## Determination 2014/038

# Regarding the compliance of access for people with disabilities to a new swimming pool at the Coastlands Aquatic Centre, Paraparaumu

**Figure 1: Approximate site plan indicating hoist and ramp positions**

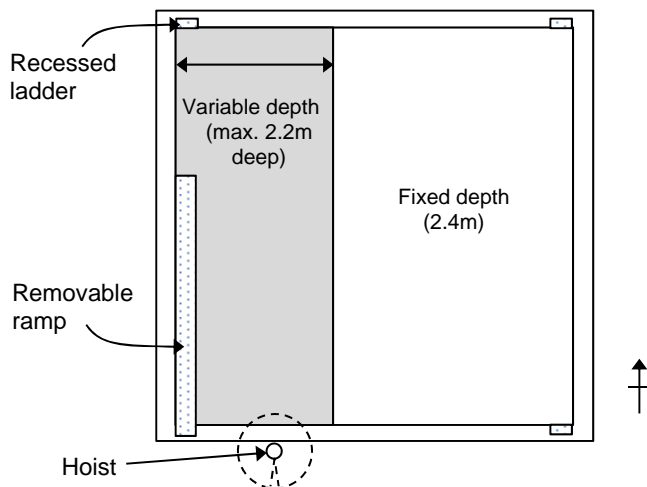
- 2.3 I have taken the side of the pool where the hoist is installed as being the southern end; the hoist is positioned approximately 6m along the south pool wall (typically in the third lane across). The hoist has a solid bucket seat, a lifting capacity of 150kg, and a push button control allowing it to be operated by the user. It rotates 360° and the seat of the hoist can be lowered to a short distance below the surface of the water.

- 2.4 The removable ramp is approximately 15.4m long and 1.2m wide, with a 1:12 slope, a non-slip surface, and handrails on both sides that run the full length of the ramp. There is a 1.2m landing located 9m down the ramp. When in use the ramp is positioned along the west wall of the pool. The ramp is constructed in sections and is on wheels; it is able to be removed from the pool by raising the moveable floor to the height of the surrounding floor level. When not in use the sections of the ramp are stacked and stored in a nearby bay on the pool concourse. Aquatic wheelchairs are available for those people who require them to enter the pool by way of the ramp.
